TEAC TECHNICAL INFORMATION

TASCAM DA-P1, No Operation with Battery Pack

DA-30MK2, DA-P1, R-9, Capstan Thrust Bearing

DA-30Mk2, DA-P1, R-9, Changes on the Mechanism Assy

Bottom View & Location of R20

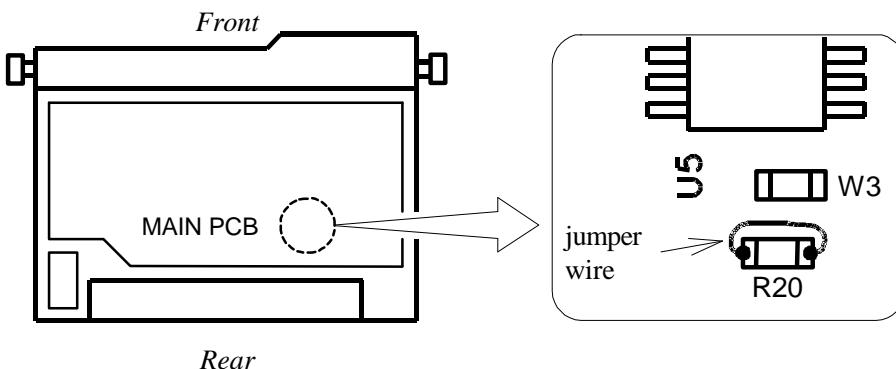
The U5, D/A Converter IC PCM1710U, requires two different voltage supply, Vdd for digital and Vcc2 for analogue. In case a difference of both voltage exceeds a certain amount while powering up, the U5 may go to latch up state. Use of full-charged battery results in the highest prime voltage supply. And it causes a chance that the U5 enters such state. This state allows to draw a huge current of +5V supply circuit. Finally, the foldback current limiting function of the U325, 3 Prong Regulator IC, works and system control is unable to start.

Remove a bottom cover and make a short circuit on R20, 10 Ω chip resistor.

Products serial numbered up to 49999 stocked in TEAC warehouse have been reworked on replacing R20 with chip jumper. They are identifiable with "C" mark stamped at the right side of serial number shown on carton. All products serial numbered 50001 and up have been modified at the production line and have no "C" mark.

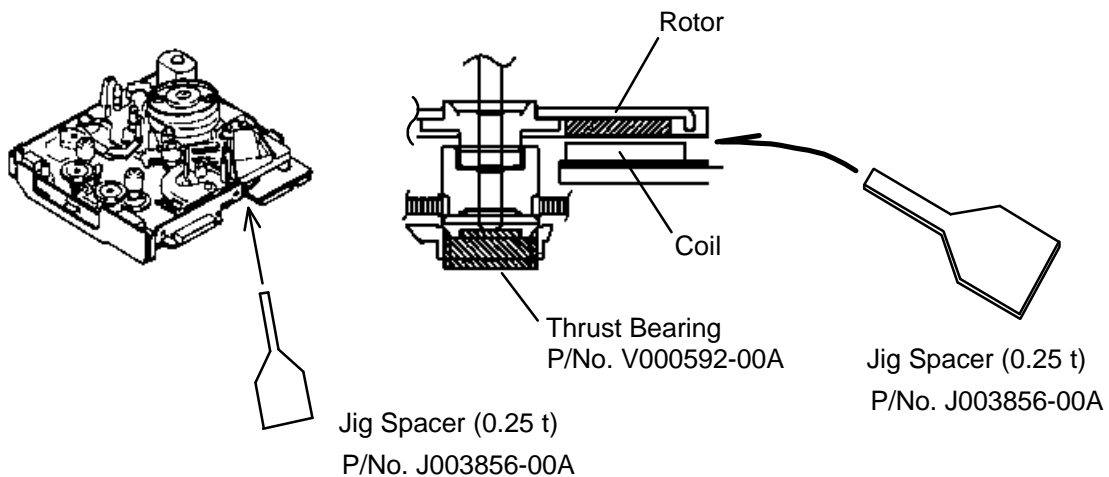
Symptom: Capstan motor does not rotate. Error 02 is indicated in the display window.

Cause: Wear of the capstan thrust bearing (Ref 4-37, S/M). The Rotor touches to the motor coil.

Solution: Change the material of the thrust bearing. Duration is improved.

New thrust bearing, **P/No. V000592-00A** has been introduced in the following products:

- 1 Dissolve the screw lock with alcohol.
- 2 Replace the old thrust bearing with new, **P/No. V000592-00A**.
 Note: Old part and new part can be identified by color difference.
 Old part is gray color and new part is black color.
- 3 Insert a jig spacer (0.25 t), **P/No. J003856-00A** between rotor and coil as shown below.
- 4 Adjust the height of the rotor by rotating the thrust bearing.
- 5 Pull out the spacer.
- 6 Secure the thrust bearing with screw lock.

1 Sensor Block (FG Head)

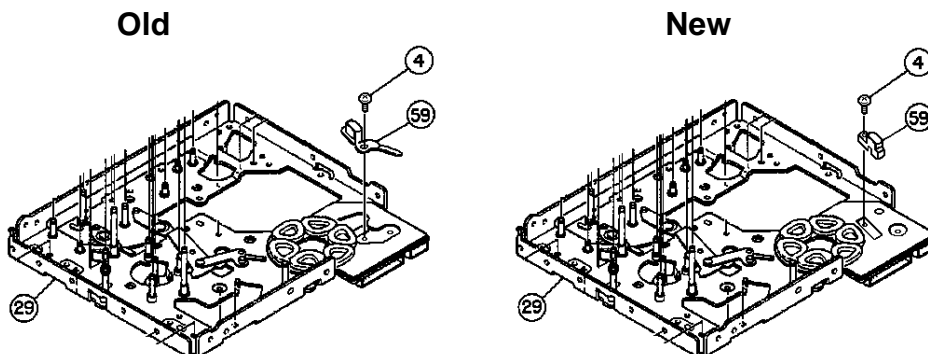
To eliminate the mechanical position adjustment, Sensor Block (Ref 4-59, S/M) has been changed. Because of the shape of the new Sensor Block, Screw (Ref 4-4) and Chassis Base Block (Ref 4-29) have been changed simultaneously. Old and new parts are incompatible.

Ref No.	Description	Old	New
4-4	Screw	V000119-00A (M1.7 × 2.5)	V000560-00A (M1.2 × 4)
4-29	Chassis Base Block	V000124-00A(DA-30Mk2/R-9) V000326-00A (DA-P1)	V000124-00B (compatible for DA-30Mk2/R-9/DA-P1)
4-59	Sensor Block	V000148-00A	V000148-00B

Mechanism Bottom View

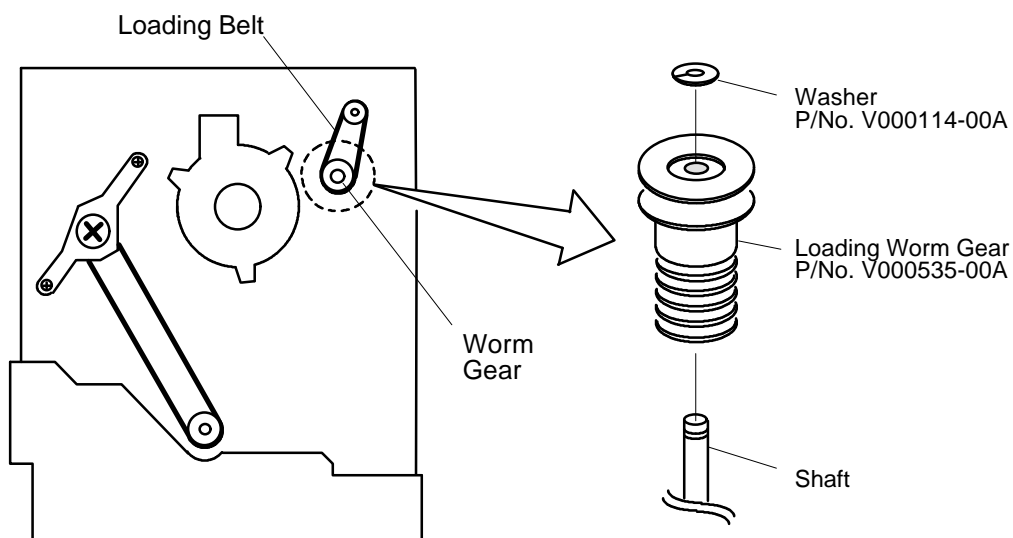
Problem: Loading Belt (Ref 4-58) slips/comes off. Error 01 appears.

Cause: Swelling of Loading Belt. Grease applied to a loading worm gear affects the belt.

Solution: Material change of the Loading Belt.

Urethane made belt, P/No. **V000135-00B** has been newly introduced on the products:

- 1 Remove and discard a swelled loading belt.
- 2 Remove and discard a washer fixing a loading worm gear.
- 3 Pull out the loading worm gear.
- 4 Fit a brand new loading worm gear (V000535-00A) which has been registered in spares.
(or original gear can be re-used if grease can be removed from the gear perfectly.)
- 5 Fix the loading worm gear by a brand new washer (V000114-00A).
- 6 Clean a motor pulley.
- 7 Fit a new loading belt (V000135-00B).

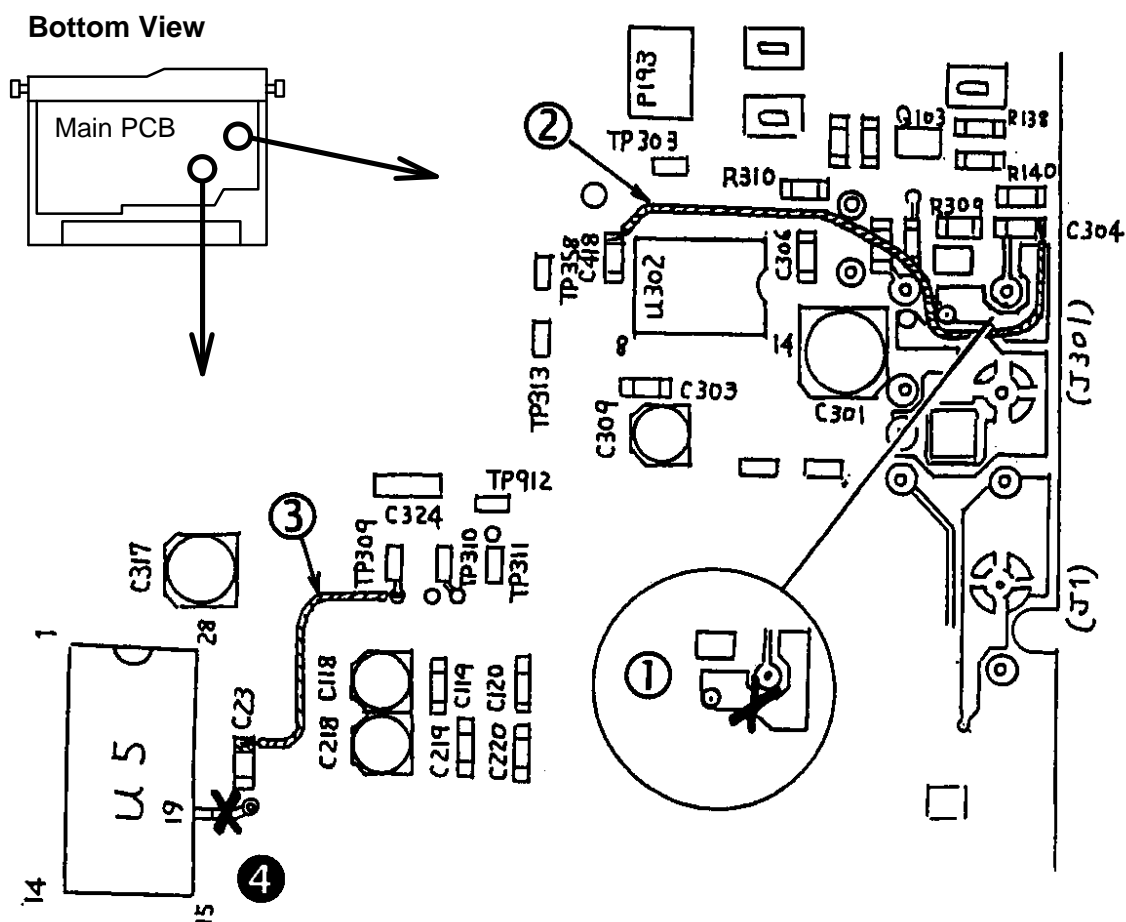
To improve the error rate, GND circuit on the Main PCB Assy has been changed on the products of S/No. 90001 and up.

- ① Cut of foil pattern.
- ② Jumper wire between C304 and C418.
- ③ Jumper wire between C23 and TP309
- ④ Removal of C34.

To locate the work point of ①, ② and ③, just remove the bottom cover.

C34 of ④ is mounted on the other side, then, Main PCB Assy should be removed/opened.

To facilitate the servicing, cut of the foil pattern shown as ④ is recommended. This is equivalent to removing C34 of ④.

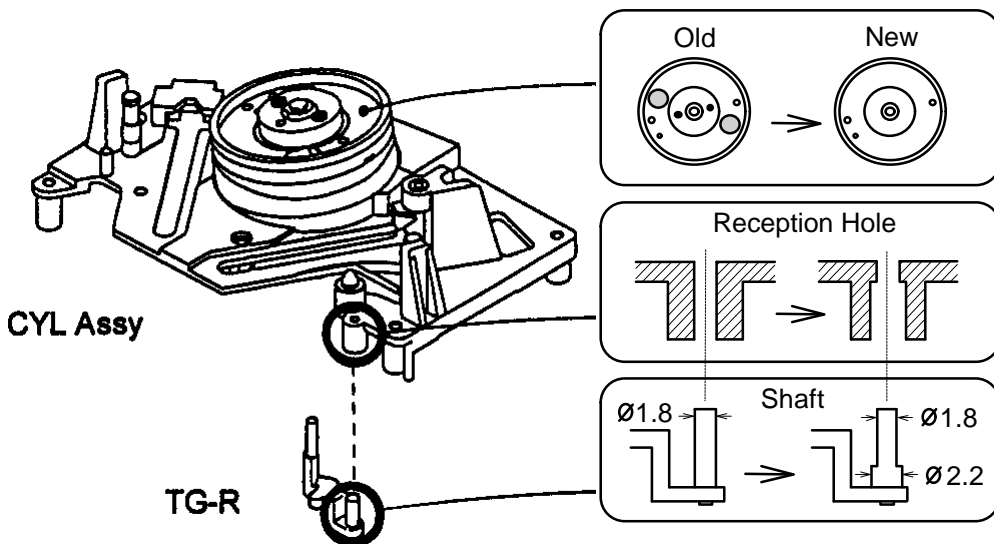
To improve the error rate on Long Play mode, track width of head A/B is securely paired.
 To improve the tape path on Shuttle Reverse mode, shaft of TG-R (Tape Guide-R) is rectified.
 Simultaneously, reception hole of CYL Assy is changed.

Note: In case old CYL Assy mounted on old unit is replaced with new (-00B), old TG-R should also be replaced with new (-00B) at the same time.

CYL Assy for DA-30Mk2/R-9	V000150-00A	→	V000150-00B	} Difference is length of motor wire.
CYL Assy for DA-P1	V000336-00A	→	V000336-00B	
TG-R	V000160-00A	→	V000160-00B

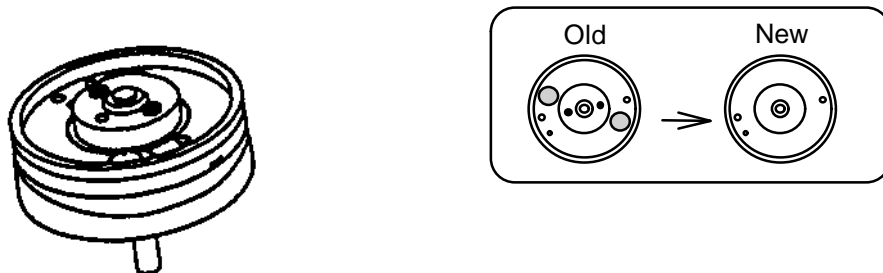
Same change (pairing of head A/B) of CYL Assy is made on CYL Head Assy introduced on Technical Information No. 9516.

CYL Head Assy	V000152-00A	→	V000152-00B
---------------	-------------	---	-------------
